Project: W. Ludington Ave. Stearns Park Improvements Phase 1 **Date:** February 25, 2019

SPEC SECTION	DESCRIPTION	REVIEW CODE
05 5213	Pipe Guardrail Shop Drawing	Make Corrections Noted

SHOP DRAWING NO: 5

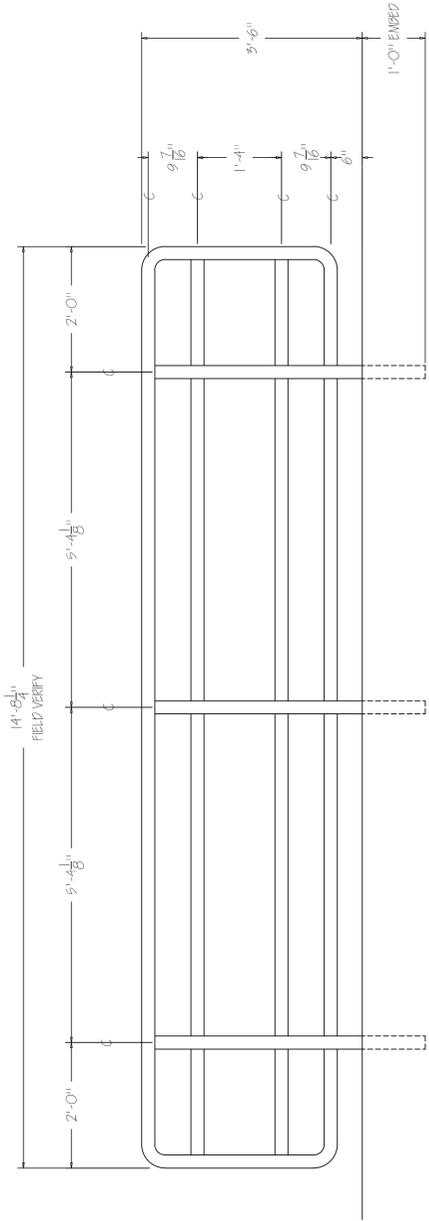
NO RAILING ON THIS SIDE. THERE IS A SEAT WALL HERE.

(3) REQ'D
 GALVANIZED
 MARK: R-11
 MAT'L: A-500

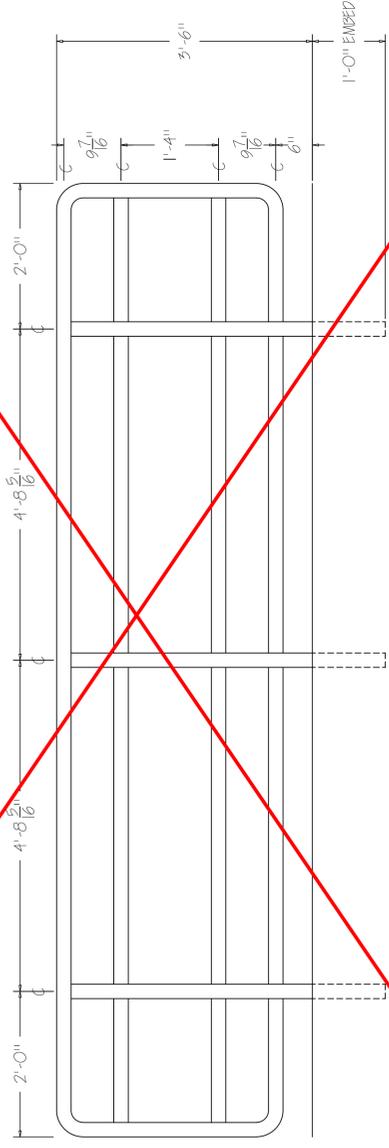
**THIS RAILING IS
 NOT NEEDED**
